November 2014 Glitch and Fix

Swap out

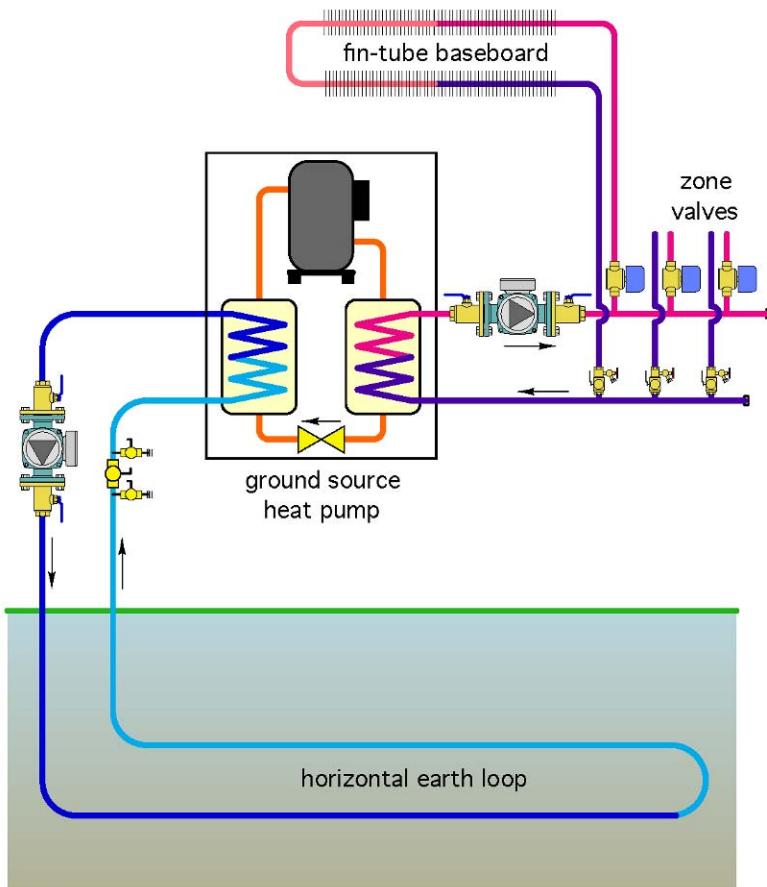
Given the current prices for fuel oil and propane, it's not surprising that some installers would view a geothermal heat pump as a replacement for an aging boiler. An installer that's used to boiler replacements may view the mechanical room aspects of changing from a boiler to a geothermal heat pump the same as a boiler changeout; just swapping out one "box" for another. Unfortunately, this can lead to some significant operating problems.

Use your knowledge of heat pump operating characteristics and basic hydraulics to identify at least five design errors in this schematic.

The vast majority of geothermal water-to-water heat pumps are single speed “on/off” devices. When on, they produce heat output at or near their rated output, depending on the exact entering temperatures and flow rates on both sides of the heat pump. Very little thermal mass is available in a heat pump to store any heat that’s produced but not immediately sent to the load.

The distribution system shown is zoned with valves; thus, flow rates and rates of heat delivery can change drastically as the zones turn on and off. This will almost surely cause “out of range” operating conditions within the refrigeration circuit of the heat pump, leading to internal safety switch trips (or worse).

Other errors in the original design include:

- The lack of air separation on both sides of the heat pump.
- The lack of an expansion tank on both sides of the heat pump.
- Lack of differential pressure control on a zoned distribution system.
- Failure to provide counter flow through the evaporator (earth loop) side of the heat pump.
- Failure to route the coolest water (leaving heat pump evaporator) through the upper portion of the horizontal earth loop.

To stabilize the situation, it's imperative to include a well-insulated buffer tank between the heat pump and the zoned distribution system as shown in the Fix drawing. The heat pump cycles on and off based on the setpoint temperature of the buffer tank and the temperature differential across which the tank needs to operate. The load circuits can now operate completely independently of the on/off cycling of the heat pump.

It's also imperative that the heat emitters are compatible with the water temperatures available from the heat pump. I suggest that the entire distribution system should be designed (or in this case redesigned) so that it can deliver design heat output with a supply water temperature no higher than 120° F. In the Fix drawing, this is represented by a change to low-temperature baseboard piped in parallel.

Details that correct these conditions are shown in the Fix drawing on the next page.
